UNITED STATES
DEPARTMENT OF THE INTERIOR
BUREAU OF LAND MANAGEMENT
SUNDRY NOTICES AND REPORTS ON WELLS

8. Well Name and No.
Cotton Draw Unit 110

9. API Well No.
30-015-36406

Devon Energy Production Company, L. P. respectfully request to make the following changes in the original APD.

Cementing Program

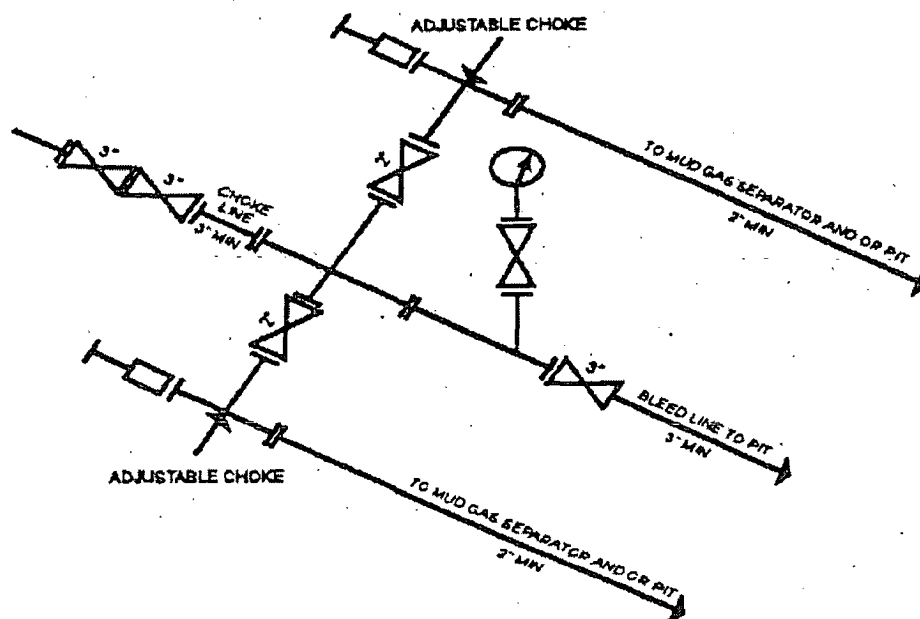
The production hole will be 8-3/4" instead of 8-1/2". See attached cementing program.

DV TOOL at ~6,000'

1st Stage

Lead: 500 sacks (35:65) Poz (Fly Ash):Class H Cement + 5% bwow Sodium Chloride + 0.3% bwoc CD-32 + 0.5% bwoc FL-25 + 2% bwoc Bentonite + 0.6% bwoc Sodium Metasilicate + 0.5% bwoc FL-52A + 102.5% Fresh Water, 12.5 ppg **Yield:** 2.01 cf/sk

Tail: 1,300 sacks (50:50) Poz (Fly Ash):Class H Cement + 1% bwow Sodium Chloride + 0.2% bwoc R-3 + 0.125 lbs/sack Cello Flake + 0.5% bwoc BA-10A + 4% bwoc MPA-5 + 58.3% Fresh Water, 14.2 ppg **Yield:** 1.28 cf/sk

2nd Stage

Lead: 400 sacks Class C Cement + 1% bwow Calcium Chloride + 0.125 lbs/sack Cello Flake + 157.8% Fresh Water, 11.4 ppg **Yield:** 2.89 cf/sk **TOC @ 3,850'**

Tail: 100 sacks (60:40) Poz (Fly Ash):Class C Cement + 1% bwow Sodium Chloride + 0.2% bwoc R-3 + 0.125 lbs/sack Cello Flake + 0.5% bwoc BA-10A + 4% bwoc MPA-5 + 63.2% Fresh Water, 13.8 ppg **Yield:** 1.37 cf/sk

3M CHOKE MANIFOLD EQUIPMENT - CONFIGURATION OF CHOKES MAY VARY
 [54 FR 39528, Sept. 27, 1989]

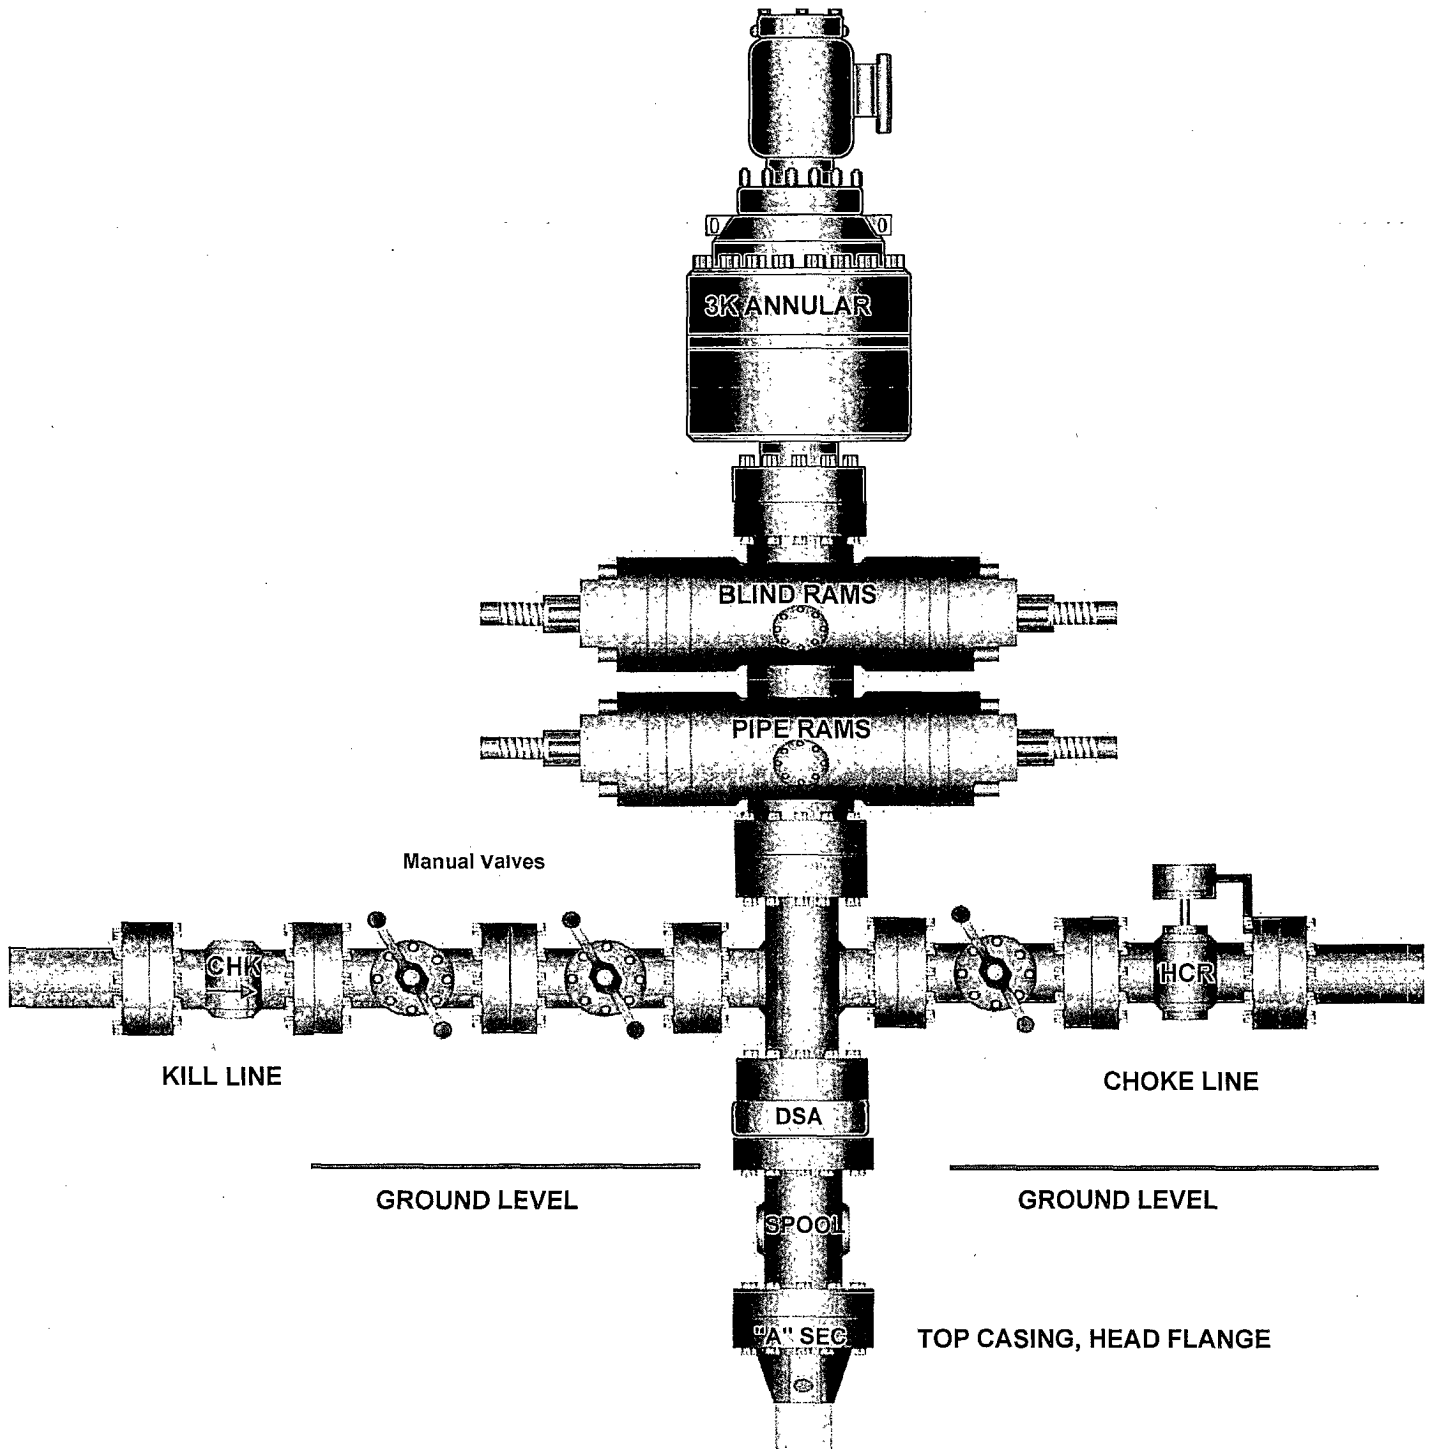
The BOP system used to drill the production hole will consist of an 11" 5M Double Ram and Annular preventer. The BOP system will be tested as a 3M system prior to drilling out the intermediate casing shoe. See attached BOP and choke manifold schematics

2. **Variance approved to use flex line from BOP to choke manifold. Check condition of 4 1/16" flexible line from BOP to choke manifold, replace if exterior is damaged or if line fails test. Line to be as straight as possible with no hard bends. Serial number 34128, safety clamps not required.**

11" x 3,000 psi BOP Stack

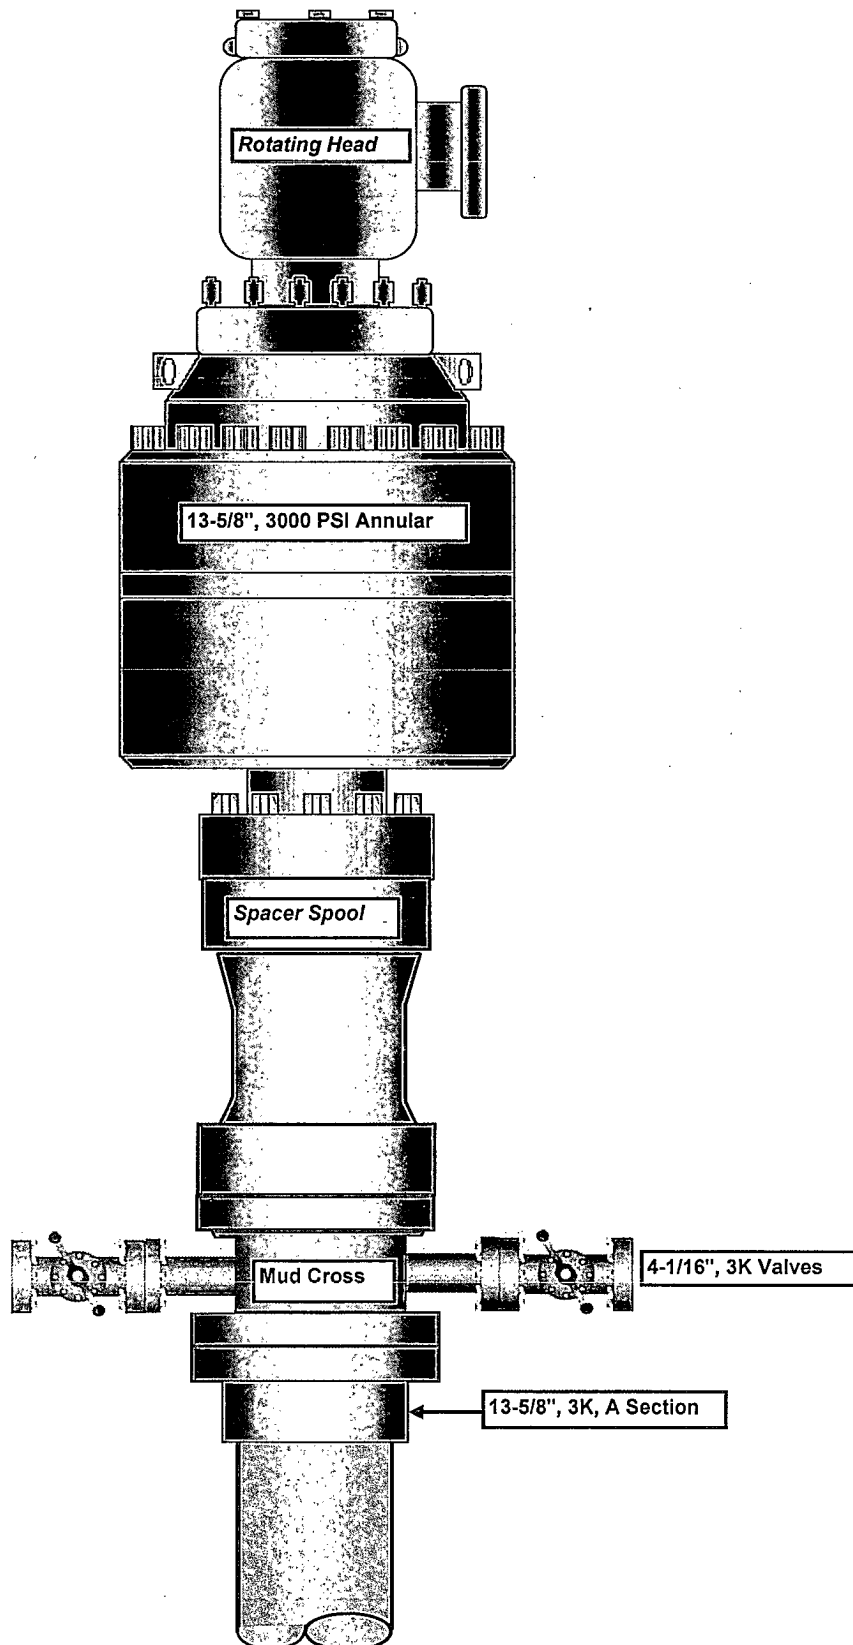
The BOP system used to drill the intermediate hole will consist of a 13-5/8" 3M Annular preventer. The BOP system will be tested as a 2M system prior to drilling out the surface casing shoe.

3. Minimum working pressure of the blowout preventer (BOP) and related equipment (BOPE) required for drilling below the surface casing shoe shall be **2000 (2M) psi**.

4. Minimum working pressure of the blowout preventer (BOP) and related equipment (BOPE) required for drilling below the **9-5/8** intermediate casing shoe shall be **3000 (3M) psi**.
